14 SUB2012-00050

HILLWOOD PLACE SUBDIVISION

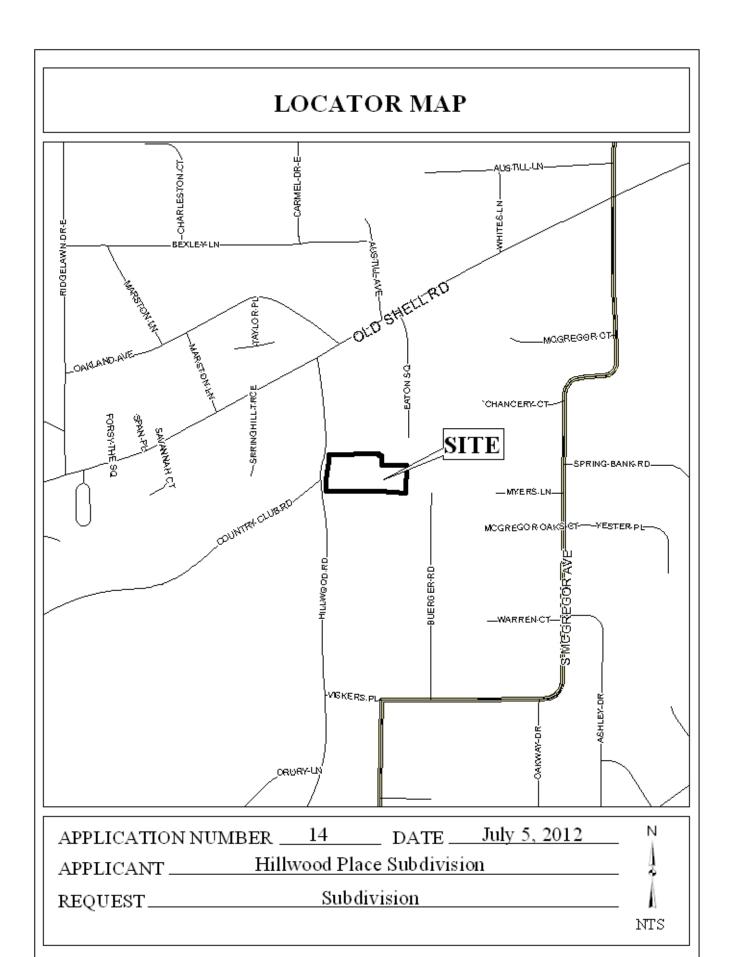
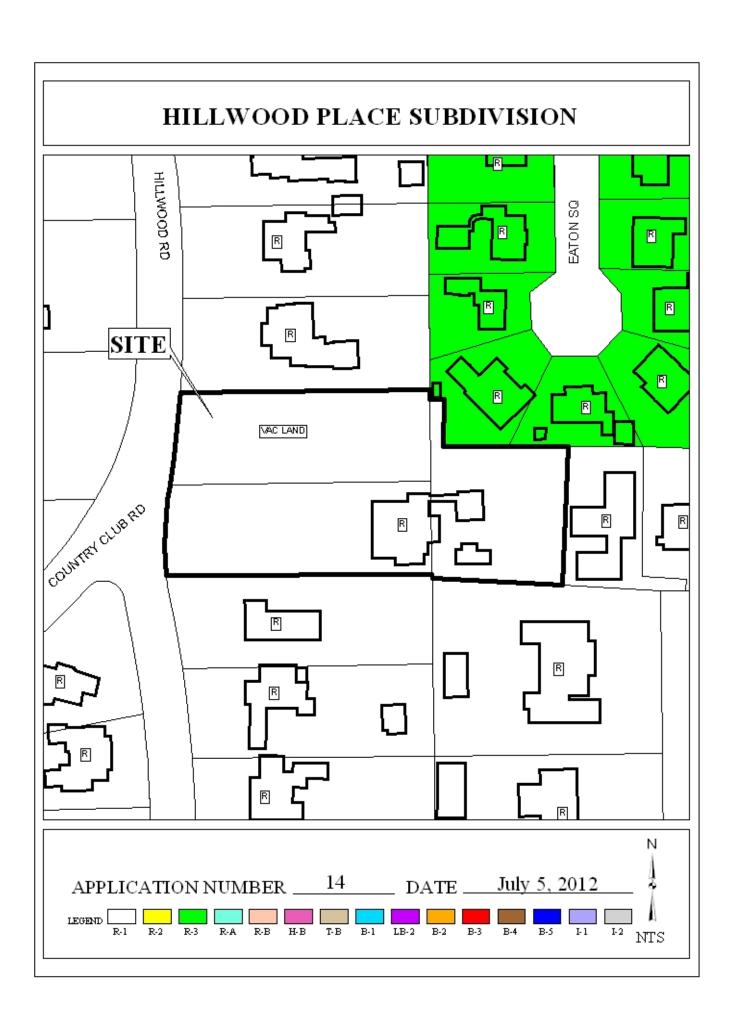
The proposed subdivision has frontage on Hillwood Road with a compliant 50' right-of-way; therefore, no dedication is required. The plat illustrates the 25' minimum building setback line along Hillwood Road on the preliminary plat. As a means of access management, a note should be required on the Final Plat stating that Lot A is limited to the two existing curb cuts to Hillwood Road, and Lot B limited to one curb cut, with the size, location, and design to be approved by Traffic Engineering and conform to AASHTO standards.

Labeling of each lot with its size in square feet/acres is absent on the preliminary plat, and should be labeled on the Final Plat, or a table should be provided furnishing the same information.

Lot A currently has a dwelling and accessory structure on it. The submitted preliminary plat does not illustrate this construction; therefore, the illustration of all structures and improvements should be illustrated on the Final Plat, if approved, to ensure appropriate setbacks.

placement of a note on the Final Plat stating that Lot A is limited to the two existing curb cuts to Hillwood Road and Lot B limited to one curb cut to Hillwood Road, with the size, location, and design to be approved by Traffic Engineering and conform to AASHTO standards;

- 2) that the location of all structures and improvements to Lot A be illustrated on the Final Plat;
- 3) subject to the Fire Department Comments: (All projects within the City of Mobile Fire Jurisdiction must comply with the requirements of the 2009 International Fire Code, as adopted by the City of Mobile);
- 4) subject to the Engineering Comments (*Provide all required information for a Final Plat review*);
- 5) labeling of each lot with its size in square feet/acres, or the provision of a table on the Final Plat furnishing the same information; and
- 6) placement of a note on the Final Plat stating that development of the site must be undertaken in compliance with all local, state and Federal regulations regarding endangered, threatened or otherwise protected species.
